- A. Title: Public Hearing for 11th Avenue Duplex (File Nos. CUP18-01 and DR18-09)
Presenter: Sarah Fox, Senior Planner

STAFF REPORT

11TH AVENUE DUPLEX

FILES: CUP18-01 AND DR18-09

GRADING AND LANDSCAPE PLAN

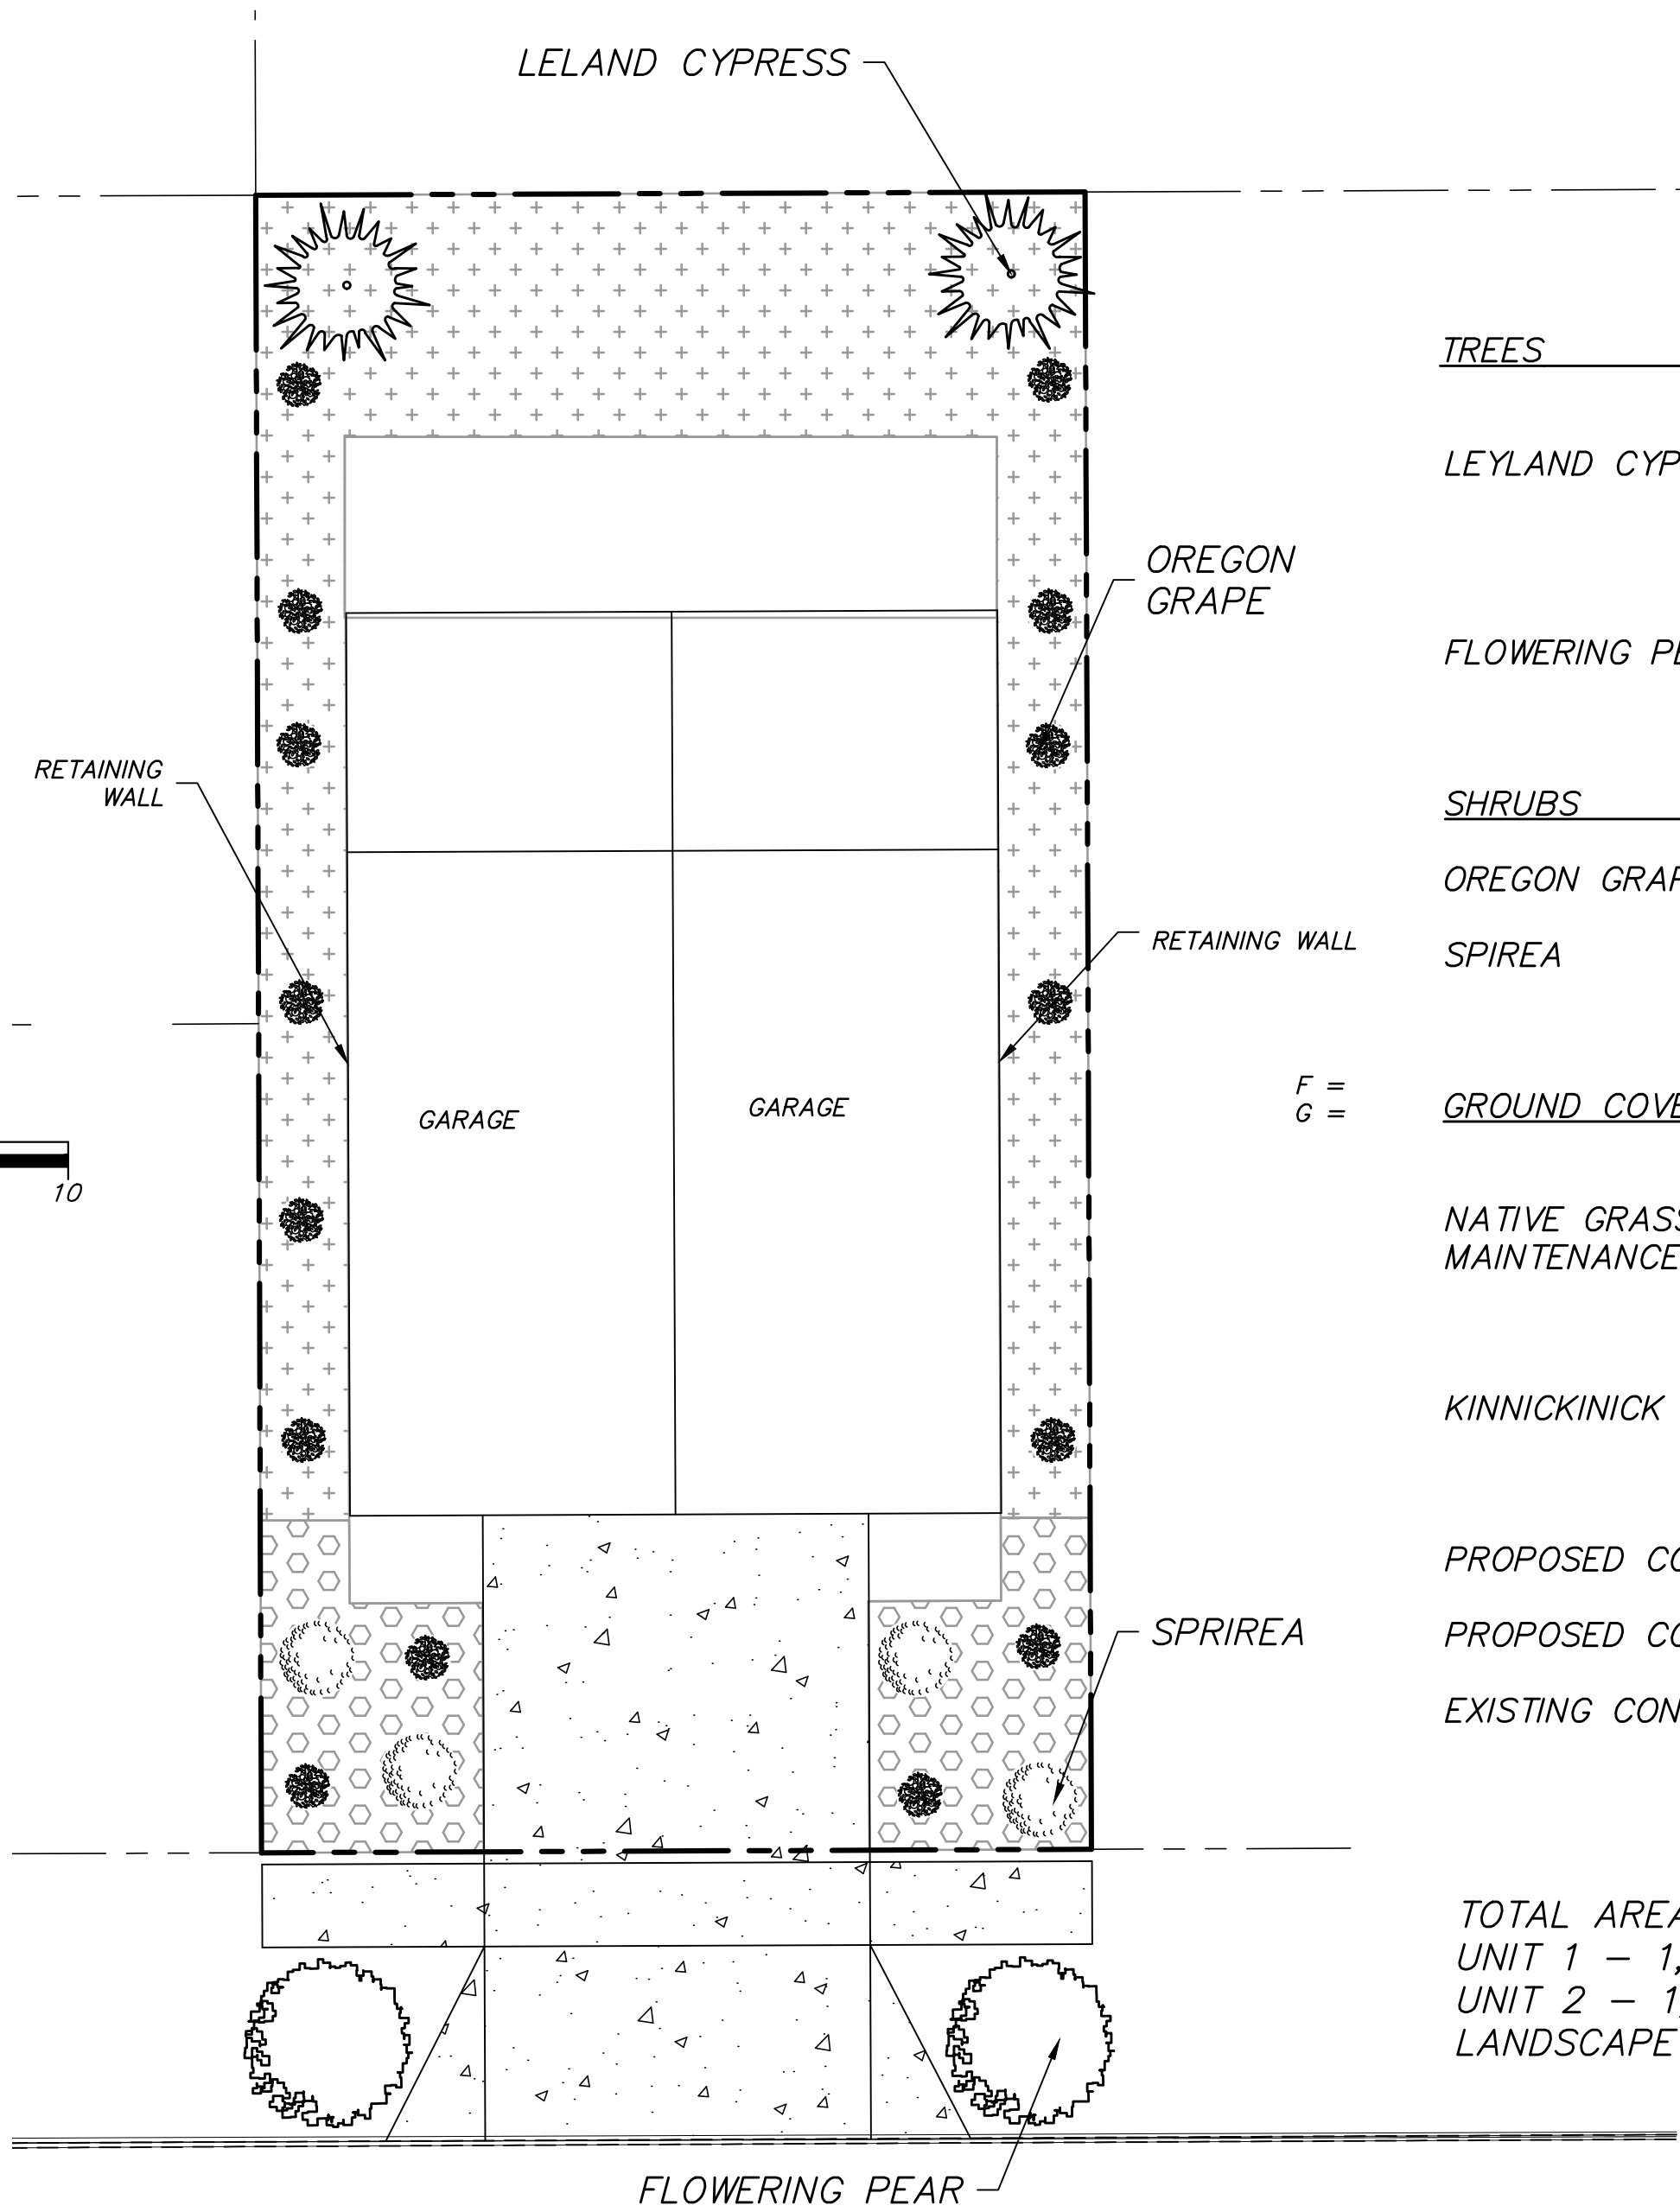
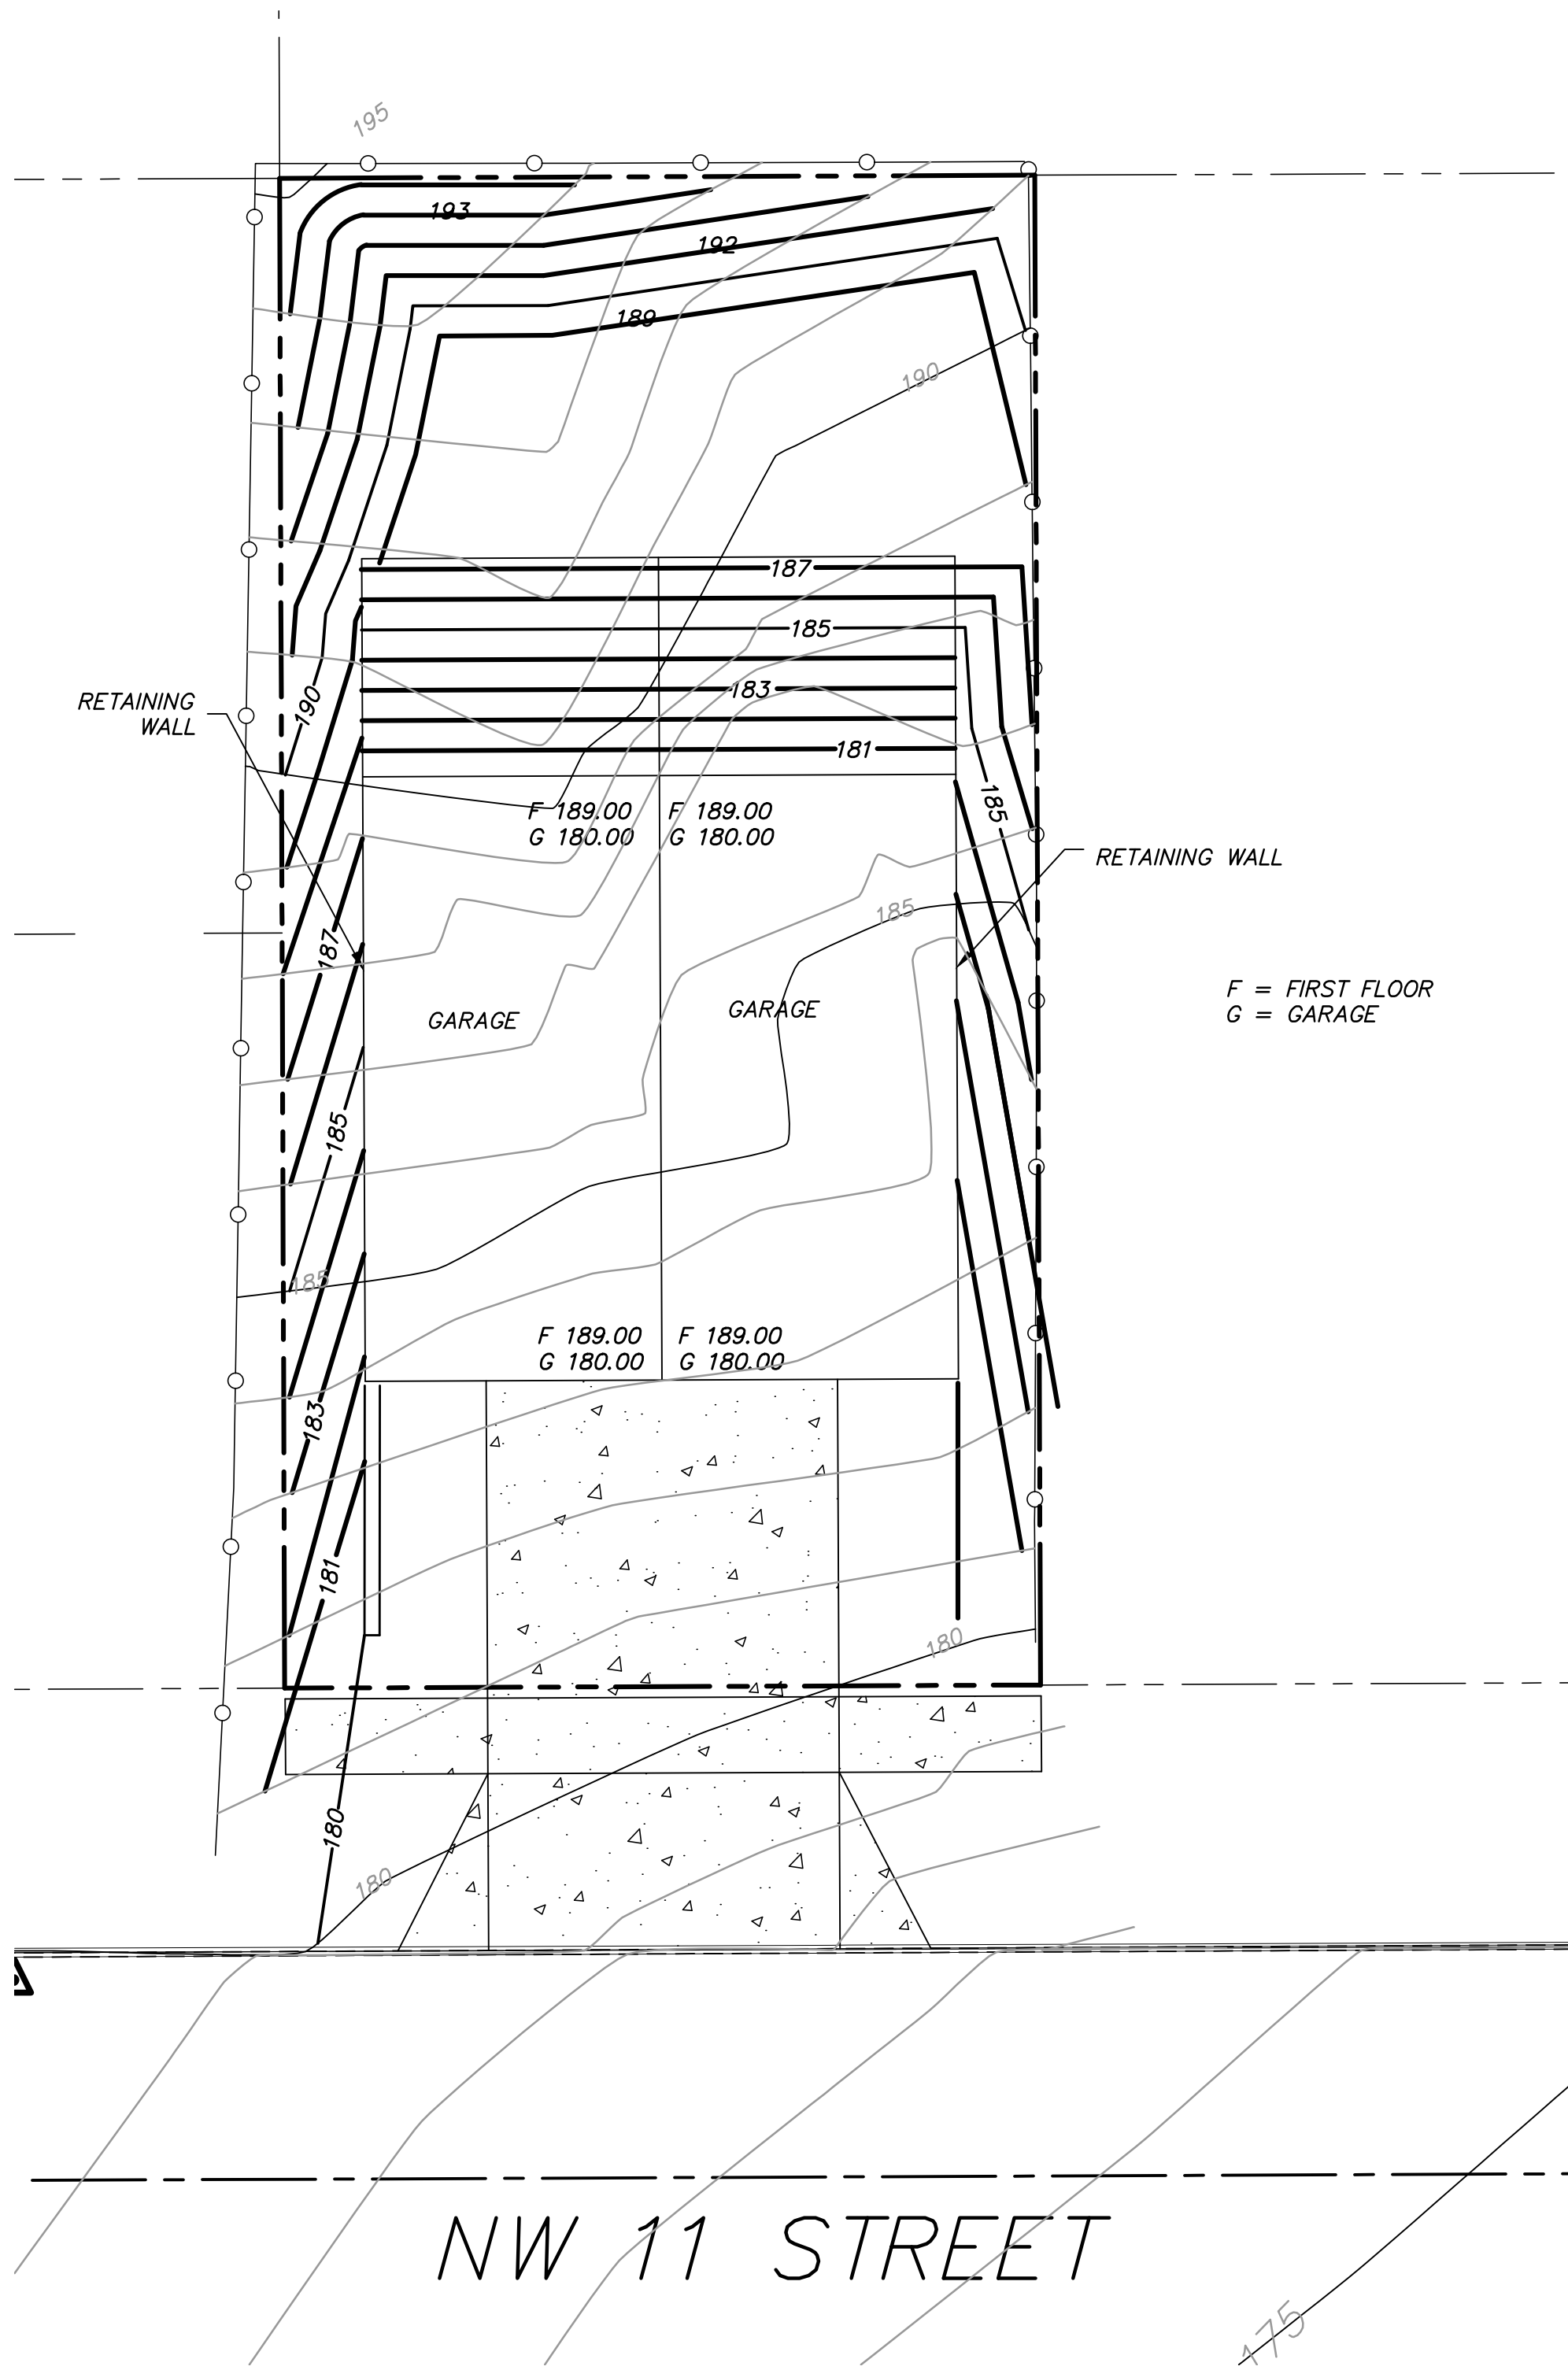
LANDSCAPING: Per drawing C3, the applicant is proposing a tree in the front yard of each dwelling unit. A street tree for every new residential unit is a requirement per CMC17.19.030 (F)(1), *"Each dwelling unit within a new development shall be landscaped with at least one tree in the planting strip of the right-of-way, or similar location in the front yard of each dwelling unit, with the exception of flag lots and lots accessed by tracts. Required trees shall be a minimum two-inch diameter at breast height (dbh) to create a uniform streetscape (dbh is four and one-half feet above the ground as measured from upside of tree)." The proposed tree in front of each unit complies with this standard.*

Findings: The landscape plan includes ground cover along the side and rear yard of Oregon grape and Kinnickinick. Front yard planting appears to include grass.

Findings: The application did not provide a proposal for an irrigation system. A condition to this effect shall be included to address this criterion.

Findings: The application includes five feet of landscaping as required between the single family residential properties to the west and east of the lot. The front yard landscaping does not group the trees and shrubs. A condition to remedy this is included.

Findings: Sheet C3 illustrates landscaping along the entire perimeter of the site to include evergreen trees at the rear of the site and ground cover plants covering the majority of the yard areas.

12. A revised landscaping plan must be provided no later than building plan submittal, and approved by the Planning Division prior to commencement of site construction. *The landscape plan will include an irrigation plan, and will group the front yard plantings as required per CMC§18.13.055.*
